Comment #177

CI 162 SC 162.11.6 P 169 L 27 # 177

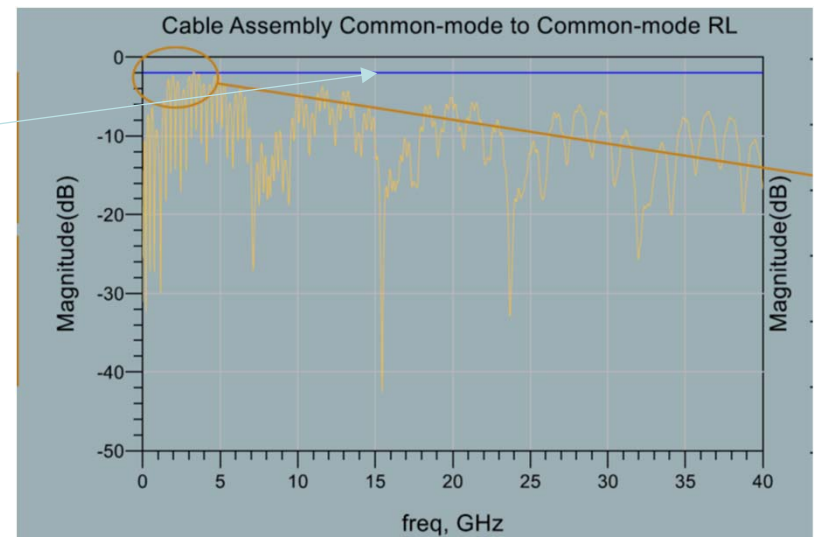
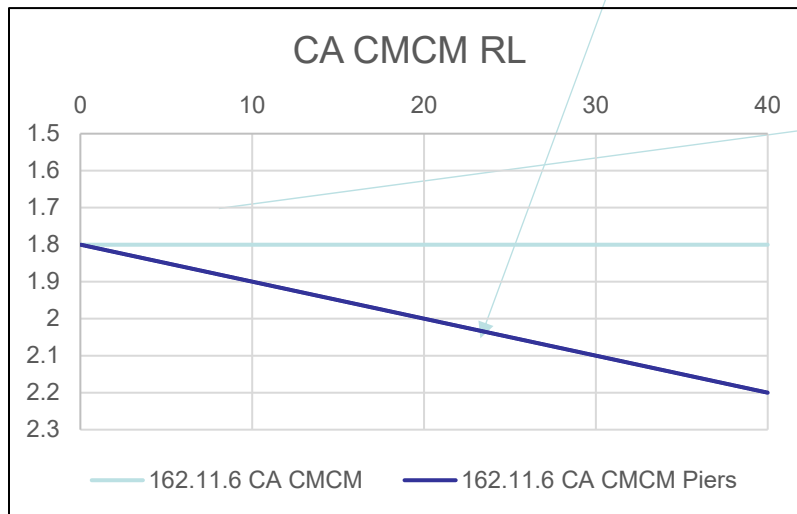
Relaxing the already very loose CM RL spec from 2 dB to 1.8 dB at all frequencies isn't justified. This spec becomes useless at the frequency when the MCB loss is 0.9 dB!

Restore it to 2 dB or use a frequency-dependent mask e.g. $1.8 + 0.01f$

PROPOSED REJECT.

The basis for the change to the cable assembly CM-to-CM RL spec from 2 dB to 1.8 dB was given in the cited presentation. The commenter has not provided sufficient justification for the suggested remedy.
